## Report to the Future Melbourne Committee

### Planning Permit Application: TP-2020-453 16 Chetwynd Street, West Melbourne

5 October 2021

### PLANNING PERMIT APPLICATION

Figure 14: Marked Up Plan showing minimum side setback

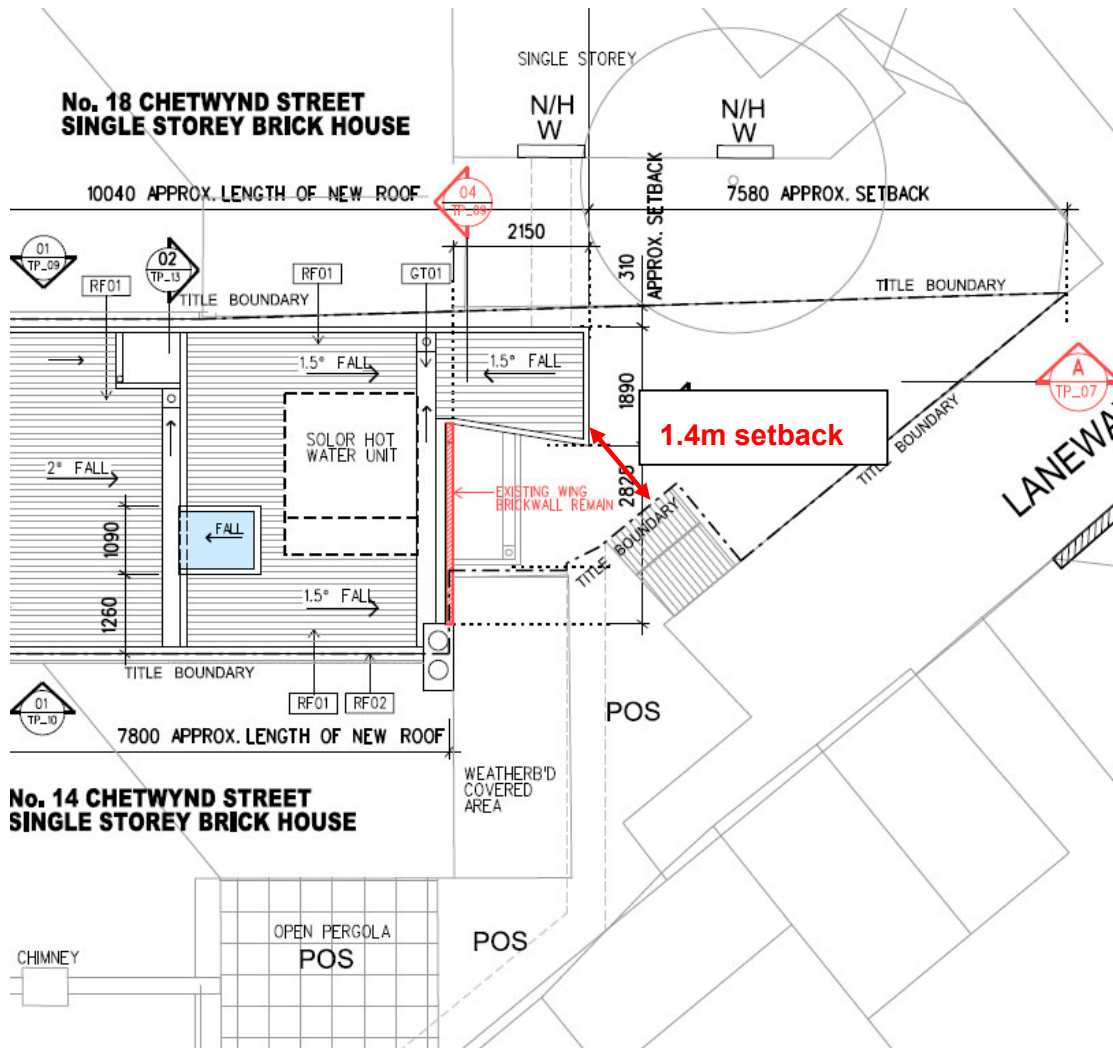
### 12.3.2 Side and Rear Setbacks

Variation is sought from Standard A10 (Side and Rear Setbacks) of Clause 54 from the boundary. The proposed addition walls are proposed to be setback 1.4 metres from the southern boundary in lieu of 1.7 metres.

Variation from the standard is considered to meet the objective of 'to ensure that the height and setback of a building from a boundary respects the existing or preferred neighbourhood character and limits the impact on the amenity of existing dwellings' because: This setback variation is a result of the rear of the lot being triangular in shape and the proposal is considered to not result in any unreasonable overshadowing of open space as discussed further in this report. The side setback complies when measured from the perpendicular section of the side lot (see Figure 15).

**Figure 16: 12pm to 2pm, 22 September Shadow Diagrams (Source: Krisna Cheung Architects)**

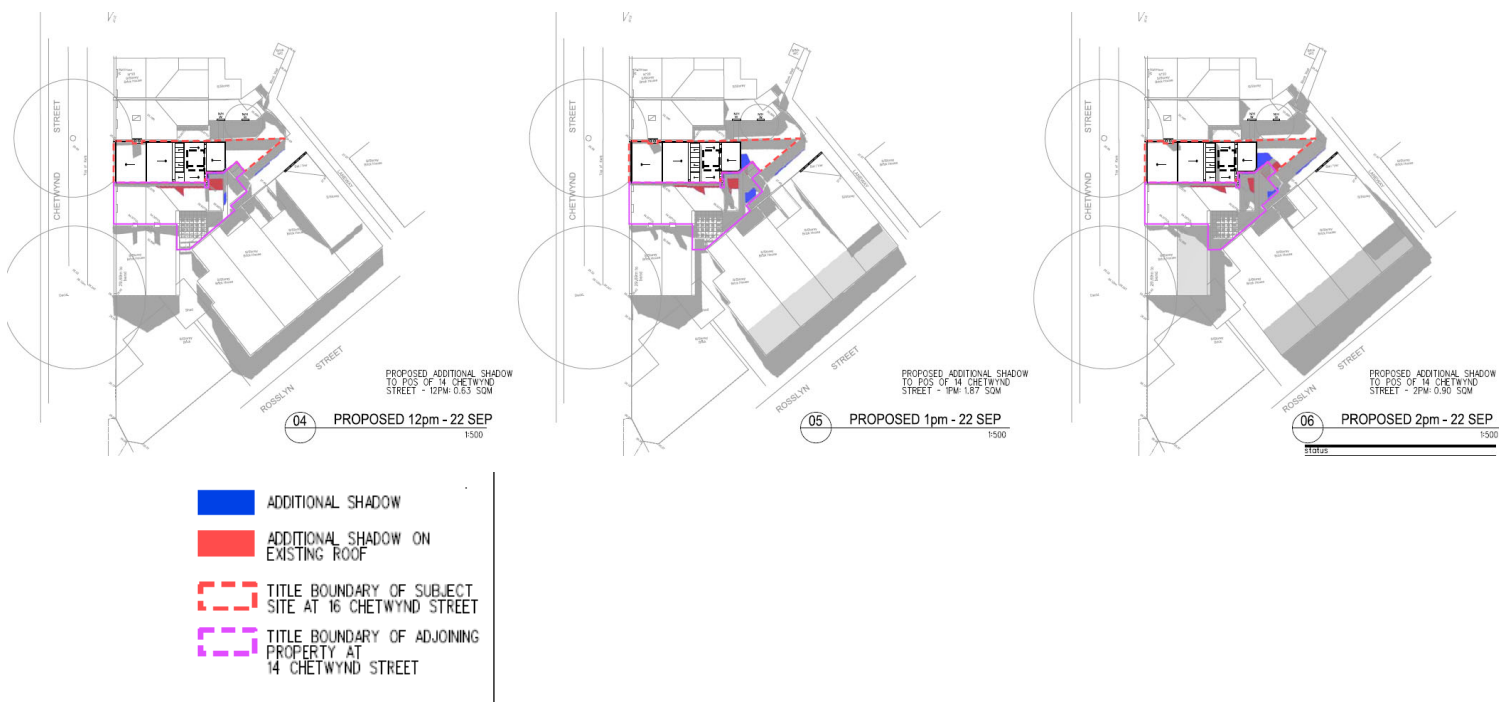
| Table 4: Existing and Proposed Overshadowing |   |                               |                             |
|--|---|-------------------------------|-----------------------------|
| 2pm  | 29.7 m <sup>2</sup><br>97%                | 30.6 m <sup>2</sup><br>100%   | 0.9 m <sup>2</sup><br>3%    |
| 3pm  | 30.6 m <sup>2</sup><br>100%               | 30.6 m <sup>2</sup><br>100%   | No change                   |

The proposal is considered to meet the objective of 'To ensure buildings do not unreasonably overshadow existing secluded private open space' because:

Figure 17: First floor plan showing light courts highlighted

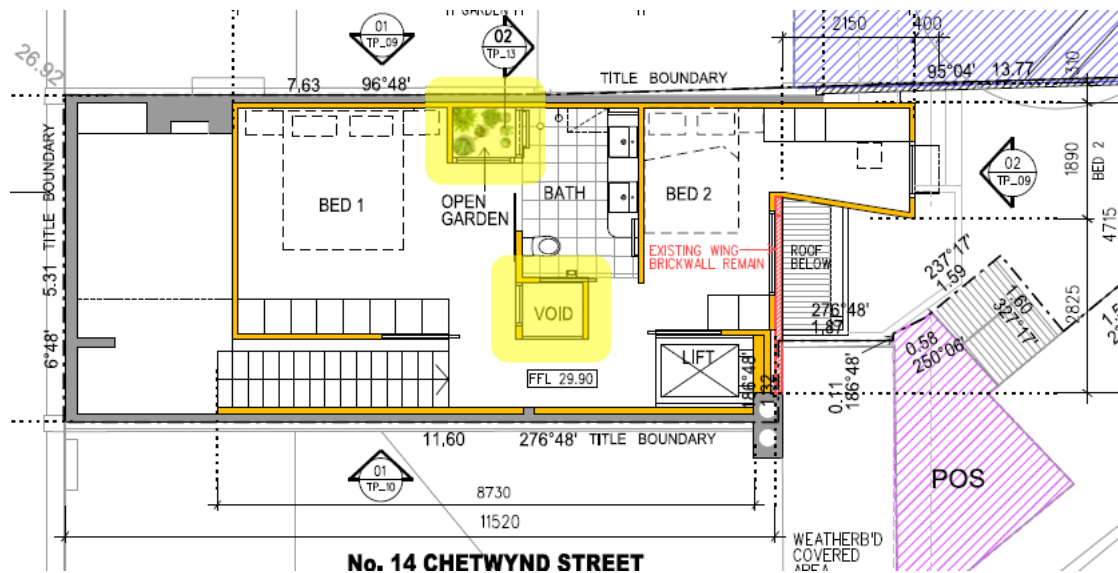
Variation is sought from Standard A16 Daylight to new windows of Clause 54. The proposal is considered to meet the objective of 'To allow adequate daylight into new habitable room windows' because:

- The proposed first-floor bedroom also benefits from light and air from a proposed skylight and thermal vent. This would allow for adequate daylight and ventilations for the bedroom.
- Should the adjoining property be developed, the light-court could be mirrored without unreasonably compromising adjoining site's development potential.
